August 28, 2025

ADDENDUM 1

City and Borough of Yakutat – Airport Water Extension

DRAWINGS**AD1.04 C305 – PLAN AND PROFILE – AIRPORT ROAD (2 OF 14)**

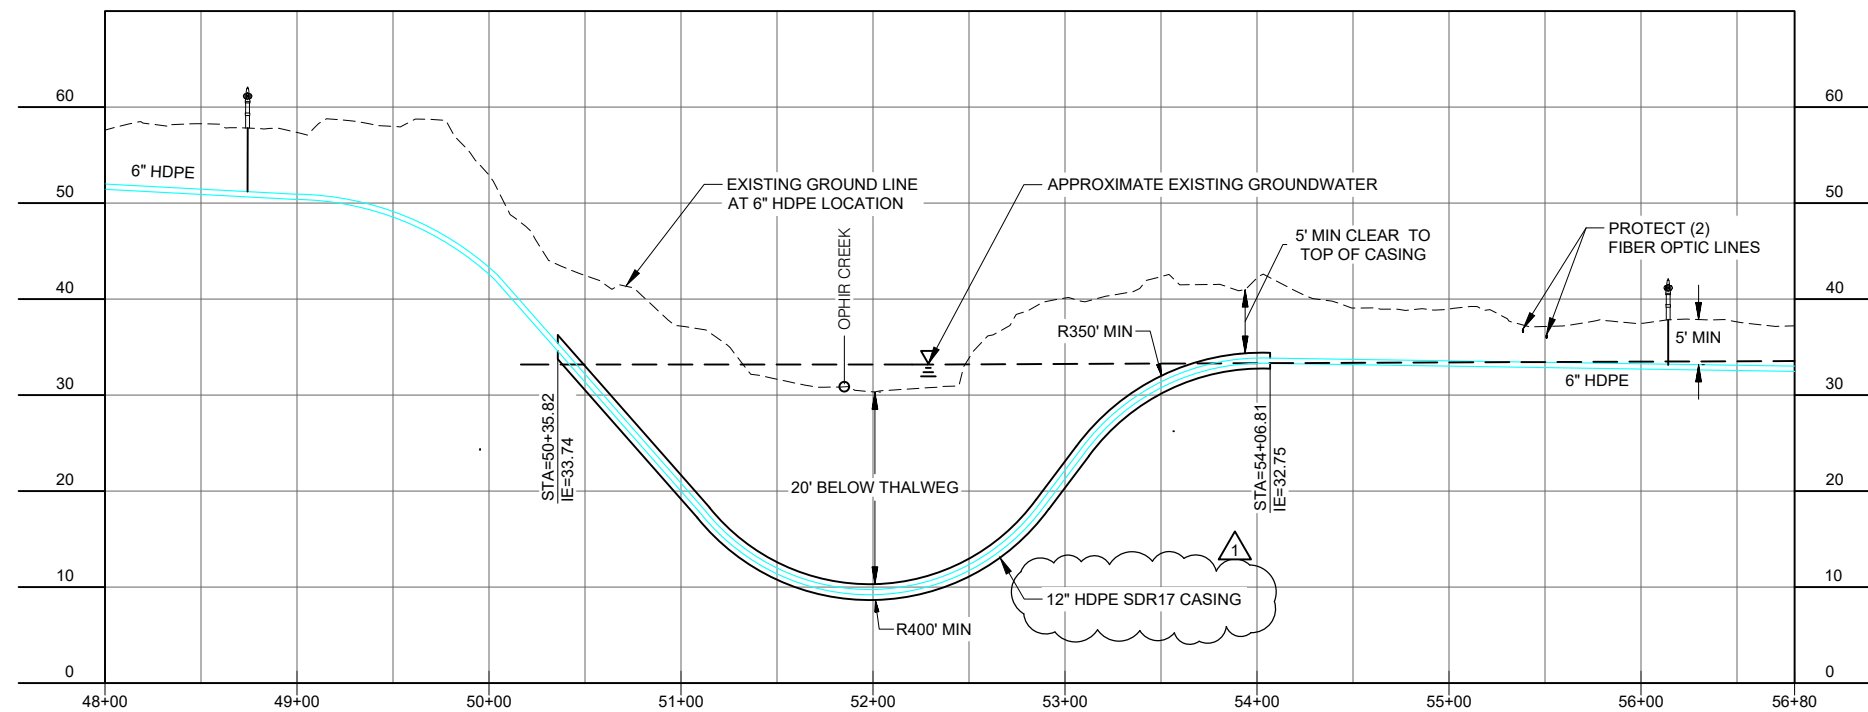
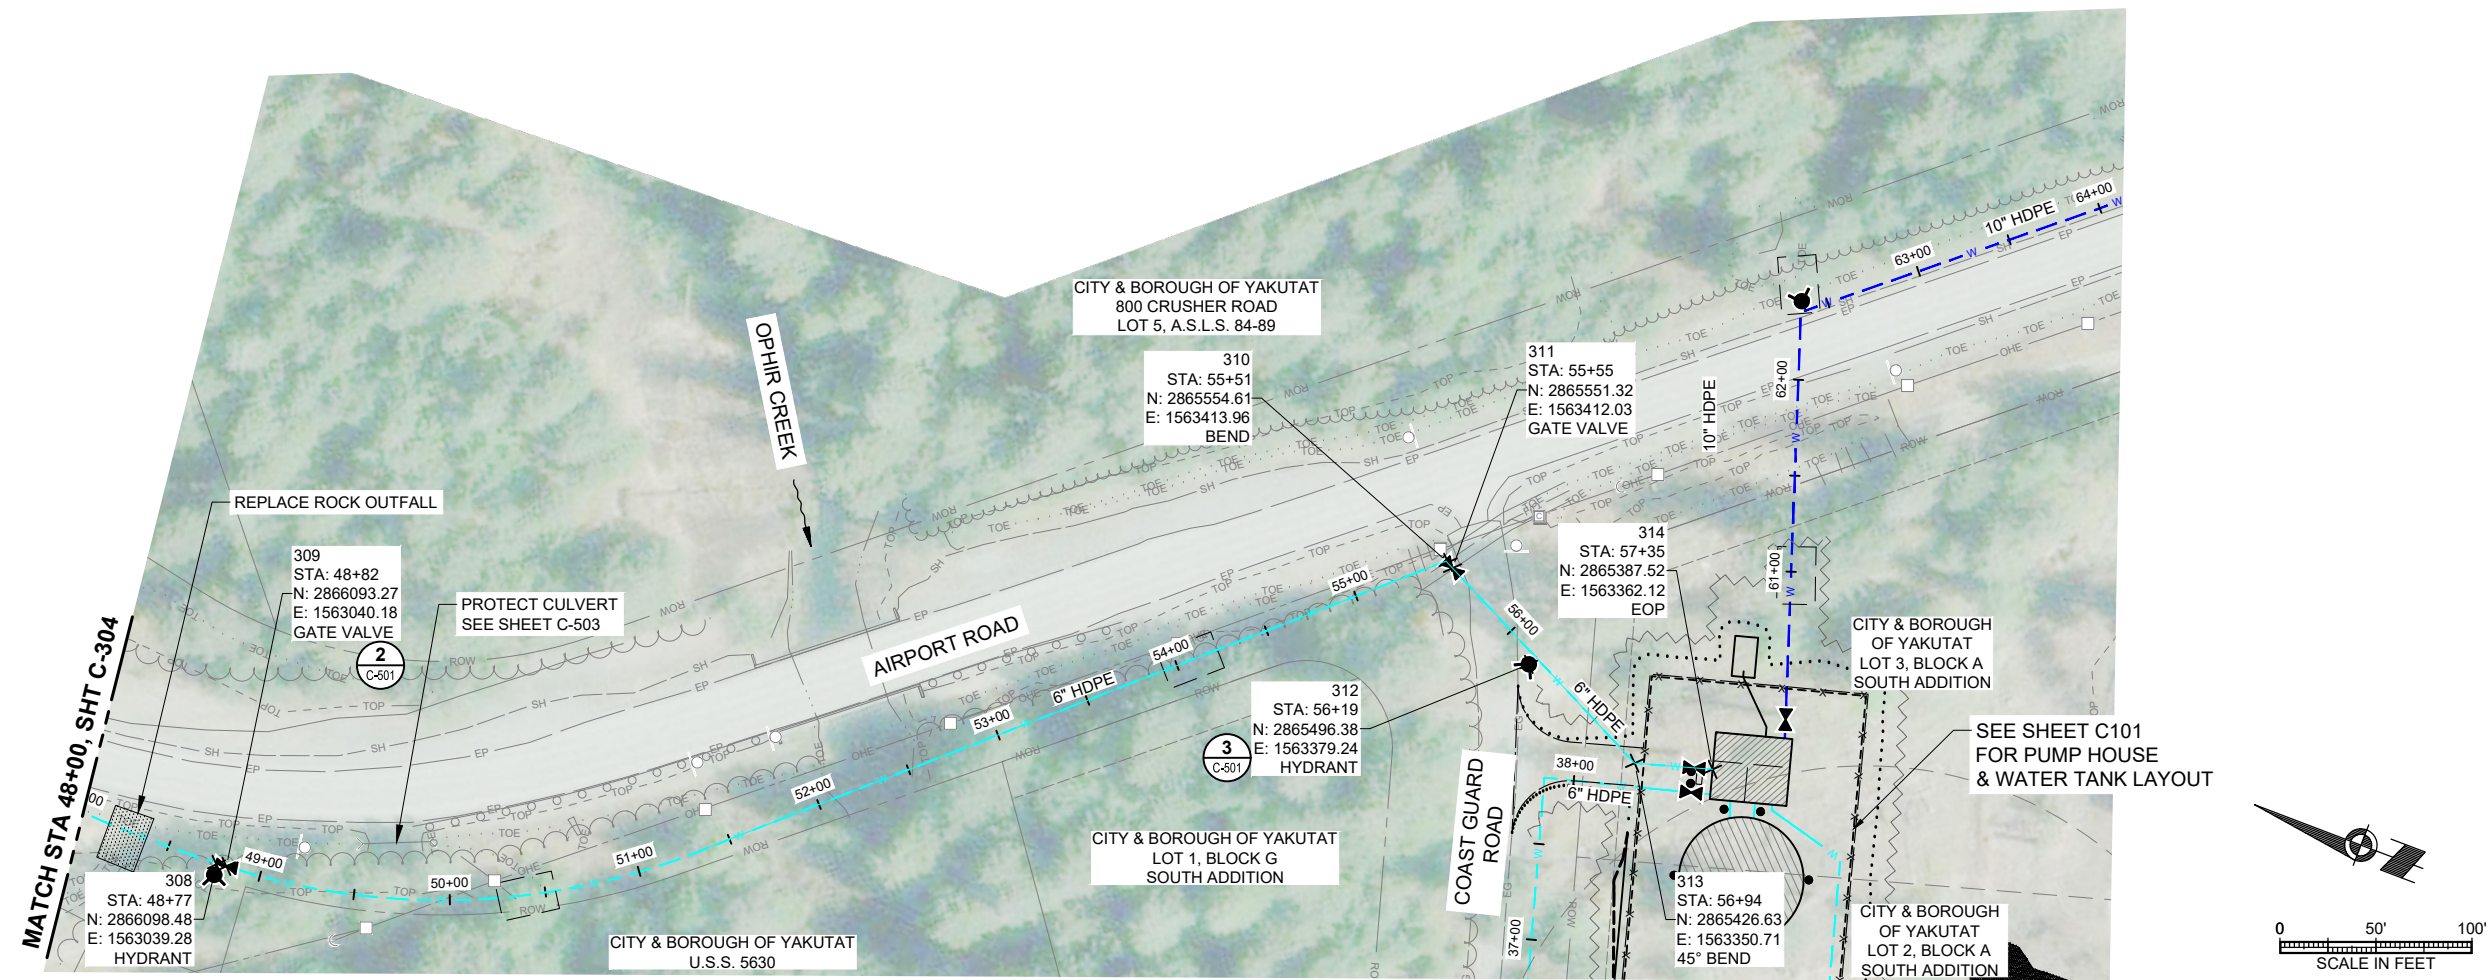
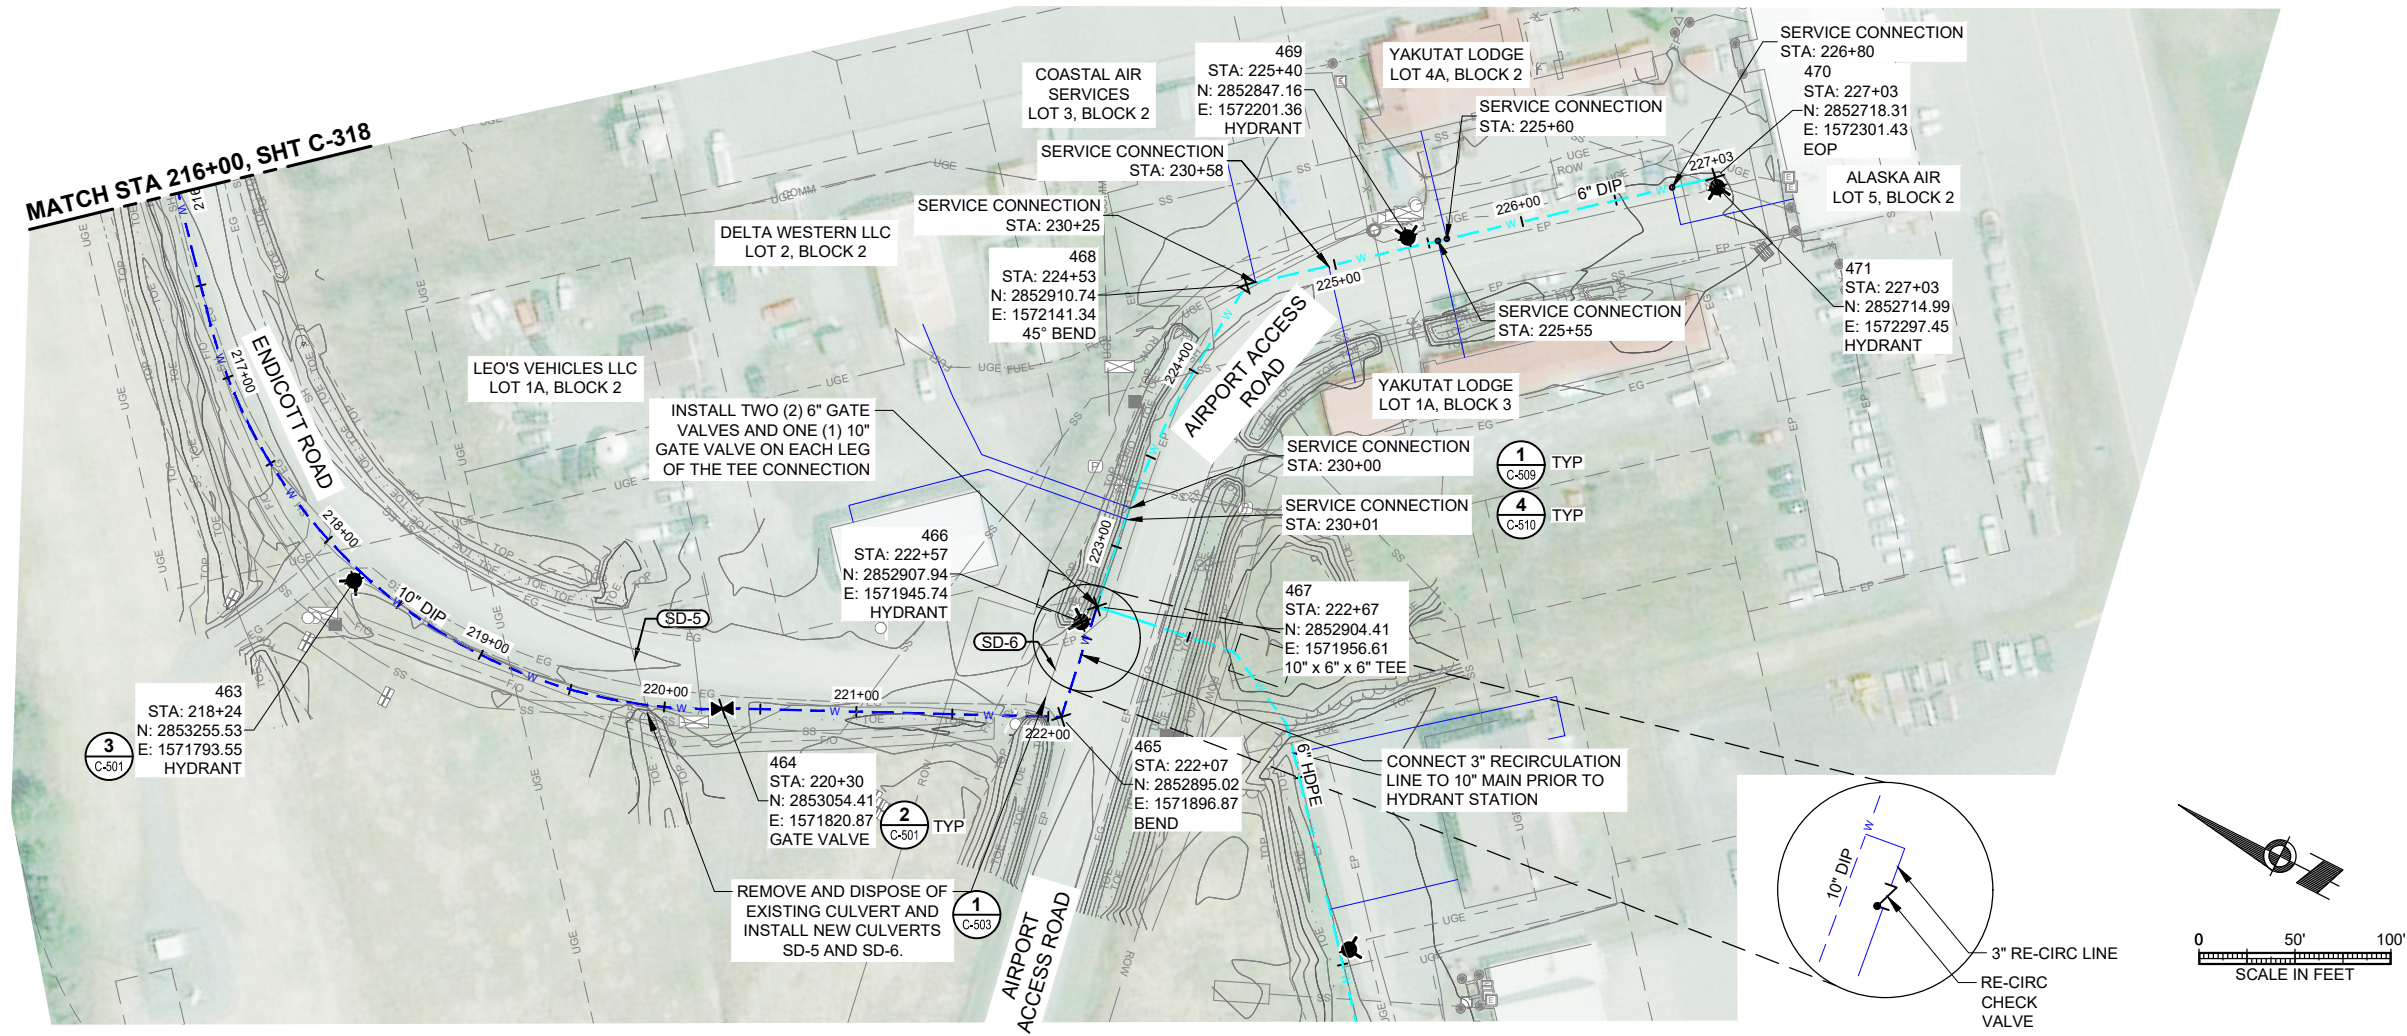
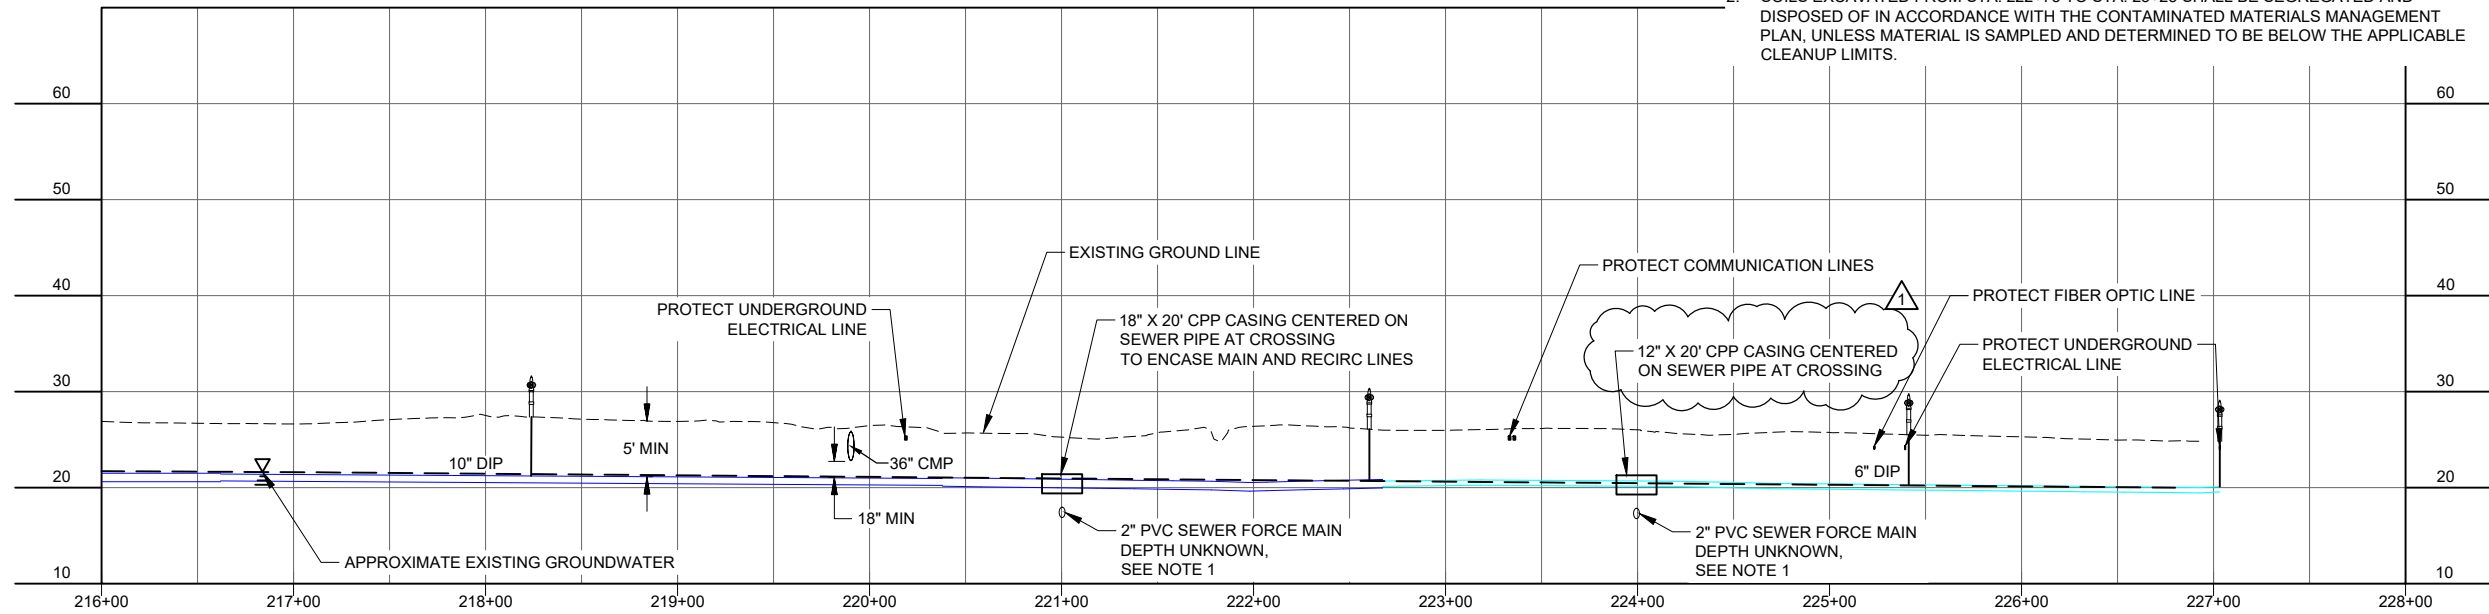
- Updated casing size at STA 50+35 – 54+06 to 12" HDPE

AD1.05 C319 – PLAN AND PROFILE – ENDICOTT ROAD TO AIRPORT ACCESS ROAD

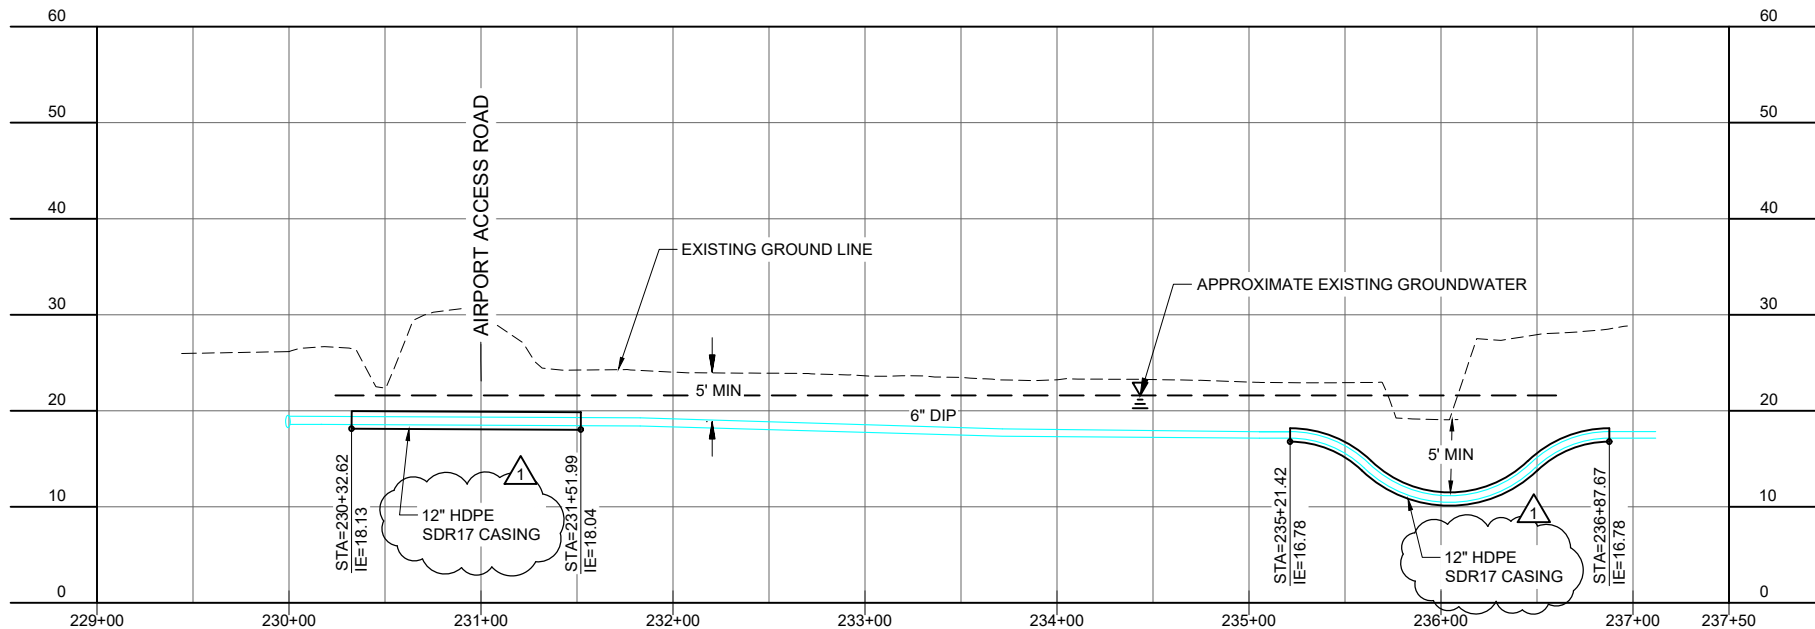
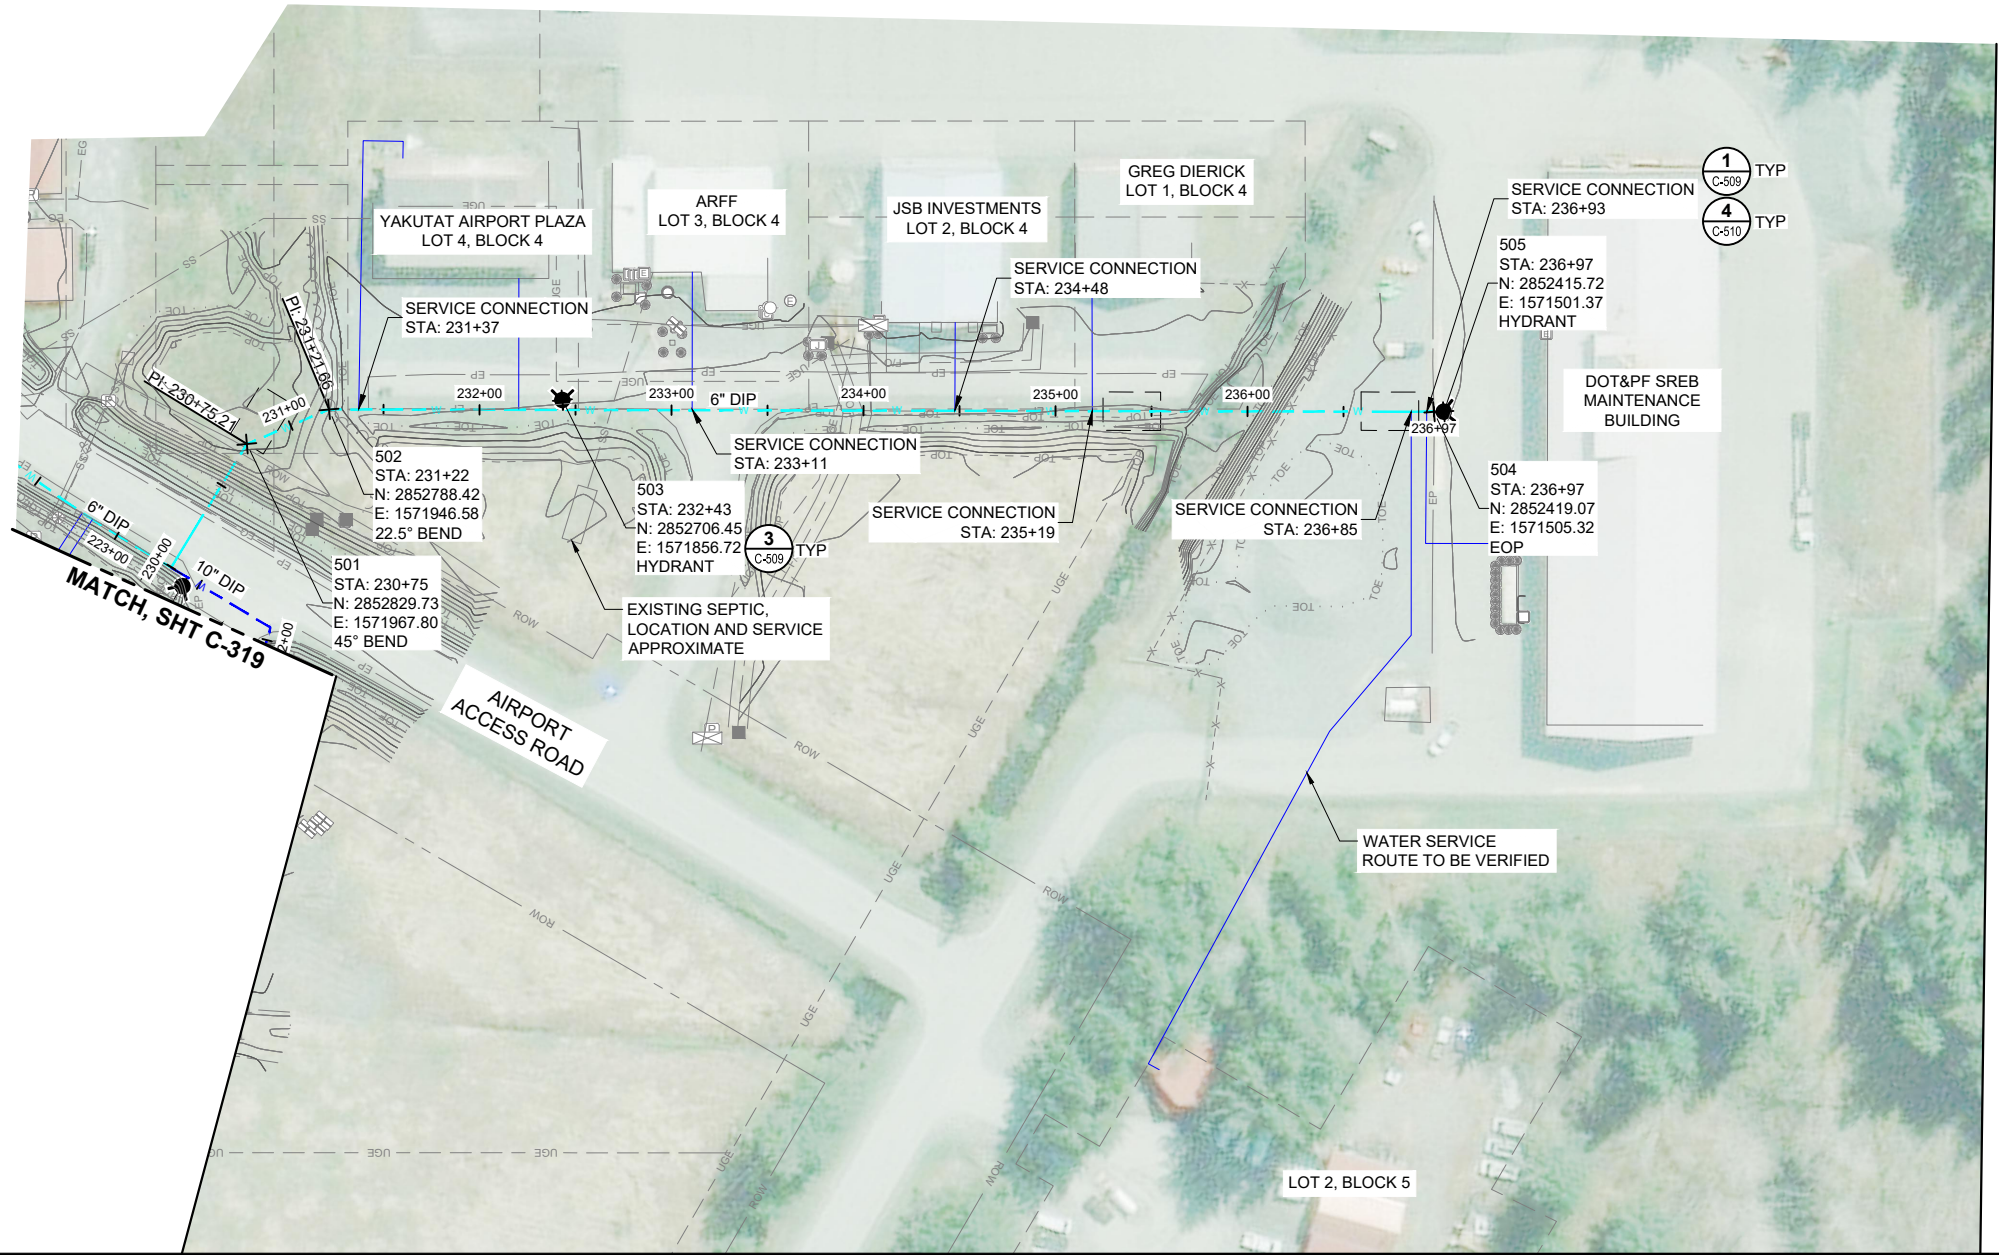
- Updated casing size at ~STA 224+00 to 12" HDPE
